PLANNING COMMISSION MEETING AGENDA

TO: Planning Commission
FROM: Troy Davis, Senior Planner
DATE: July 25, 2018
FILE: DRA18-001 Duvall Village & Duvall Cultural & Performing Arts Center

Duvall Village
A 99 Unit Townhome Development
Duvall, Washington
1313-WLD Duvall Village, LLC

Building Type CBAD
Preliminary Elevations Style A
Modern Farmhouse - Paint Scheme 2

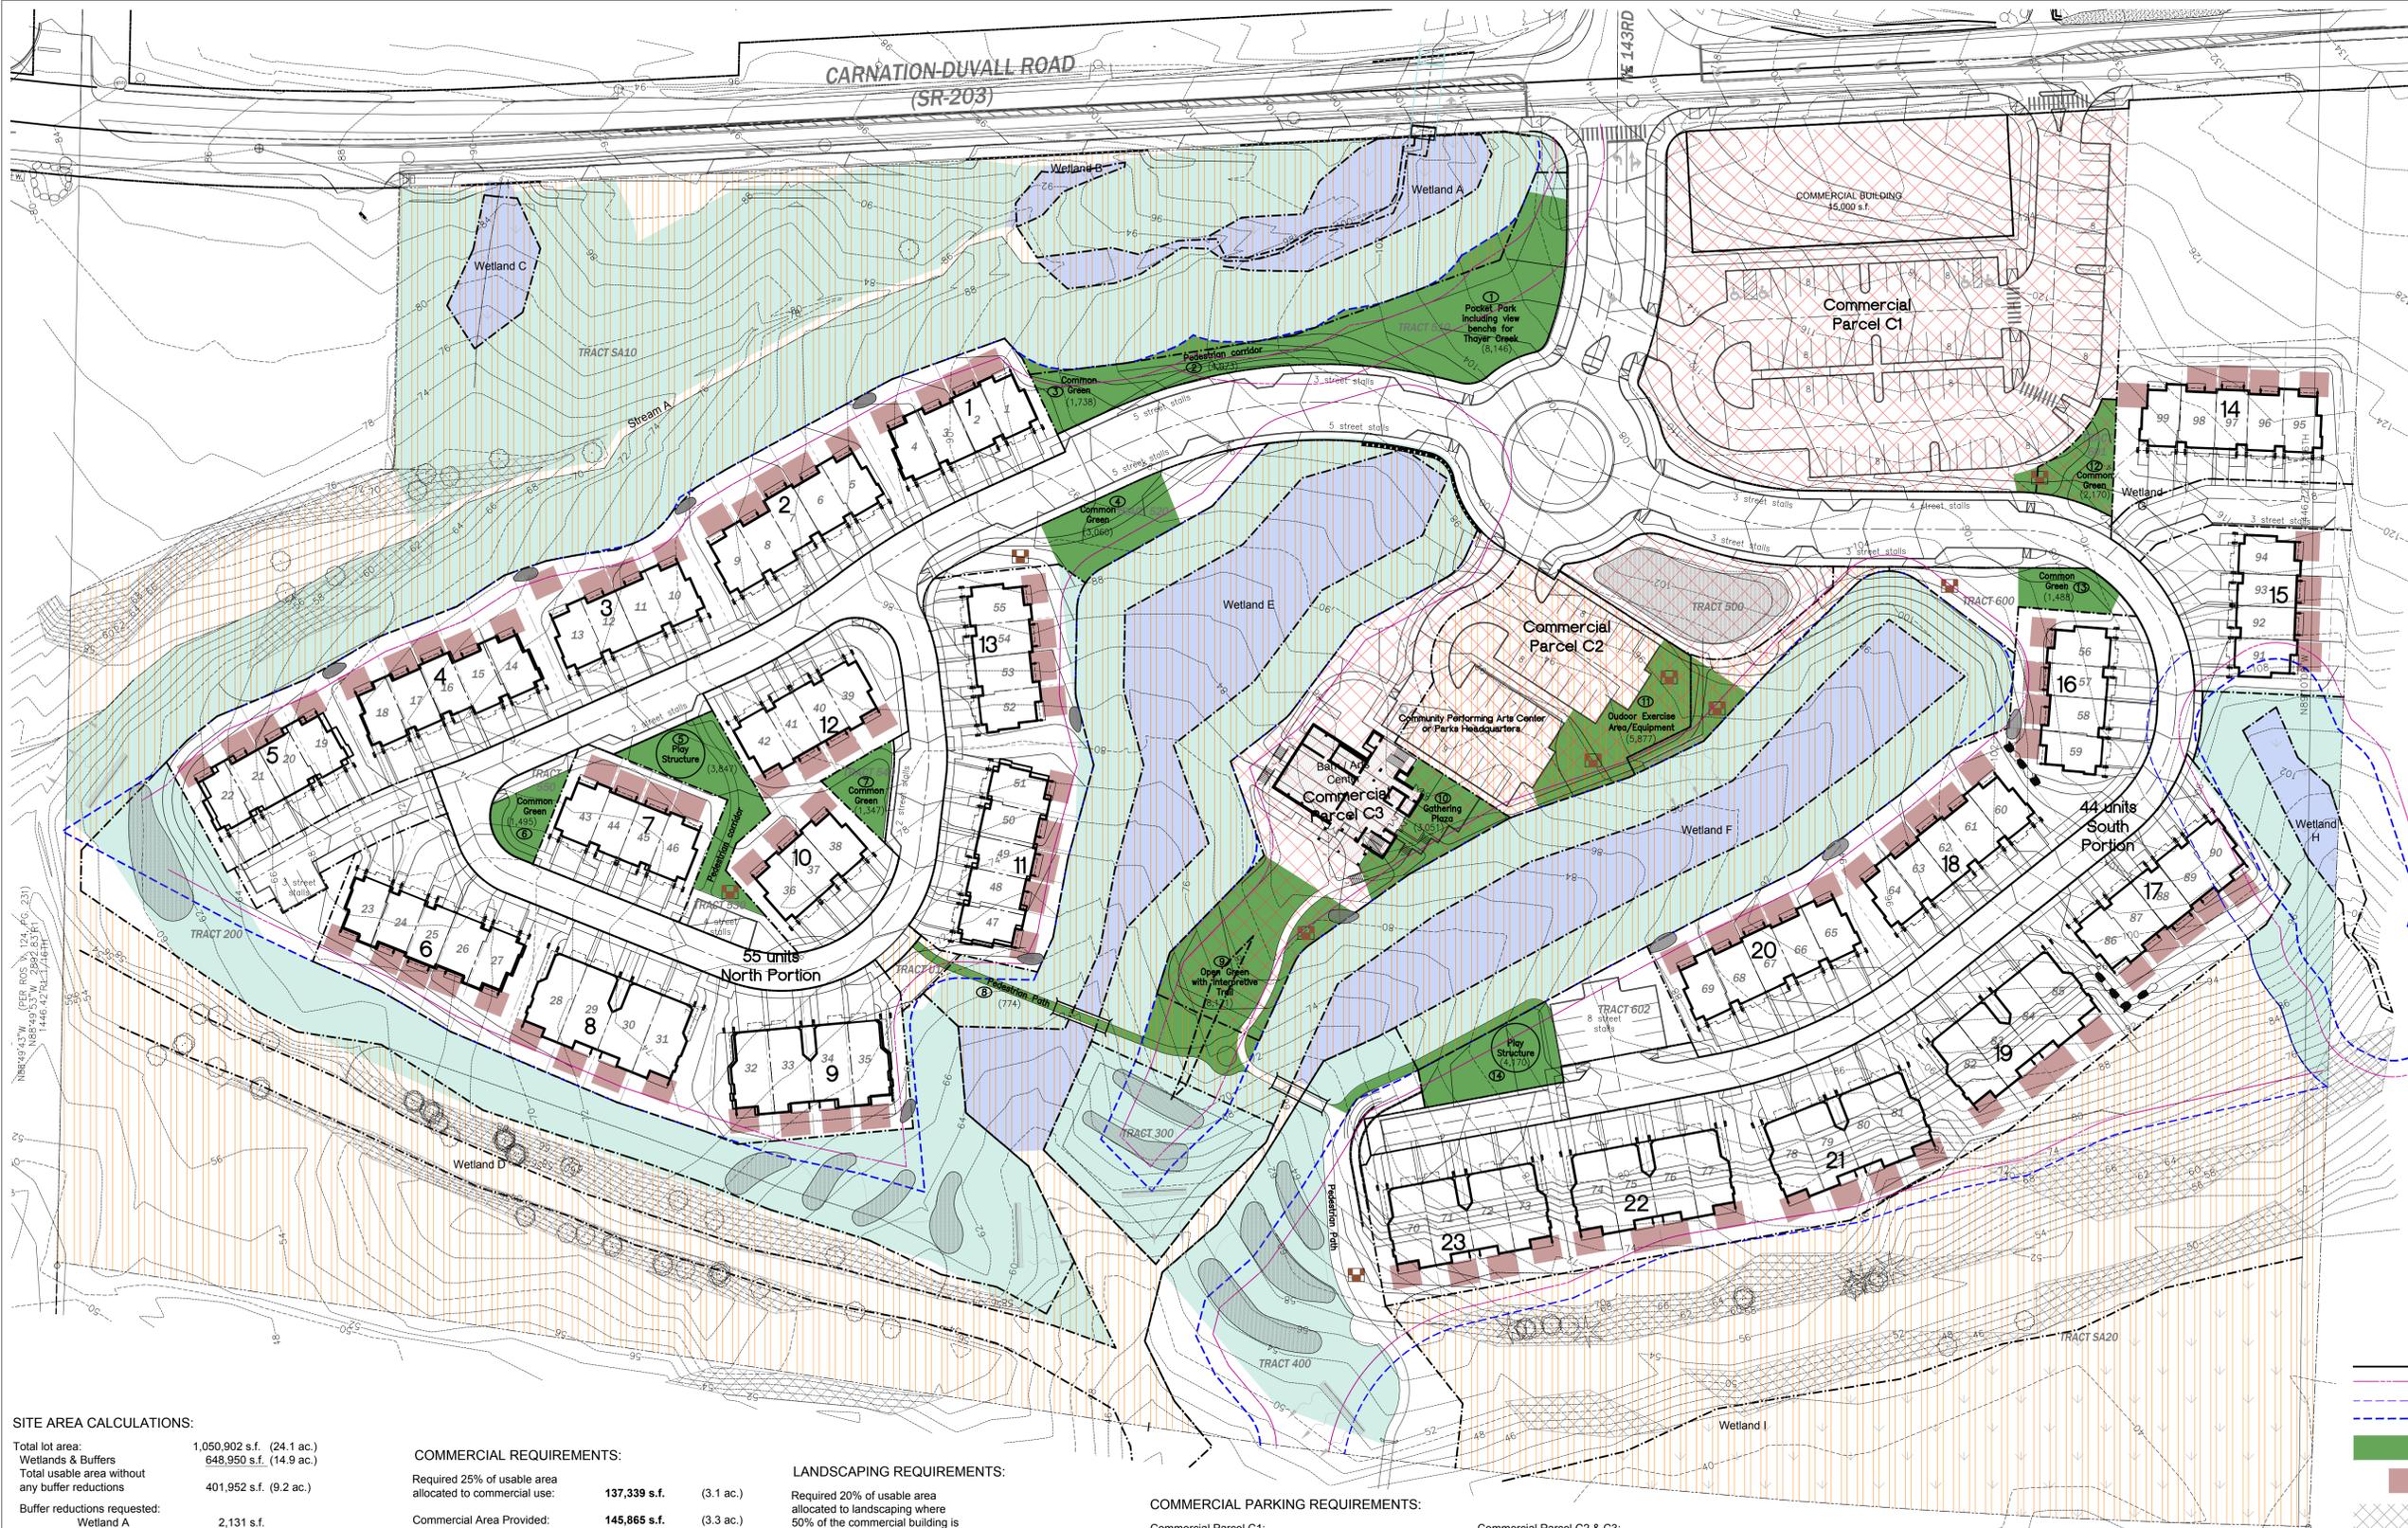
- A.10 Architectural details – Request to confirm that trim dimensions are in compliance.
- A. All of the trim at doors and windows for all the styles and building types are at least 3 ½” and are in compliance.

- A.10.d.ii Columns – Request to confirm that all posts are wrapped.
- A. All of the columns in the project will be wrapped and there will be no exposed 4x4 or 6x6 posts.
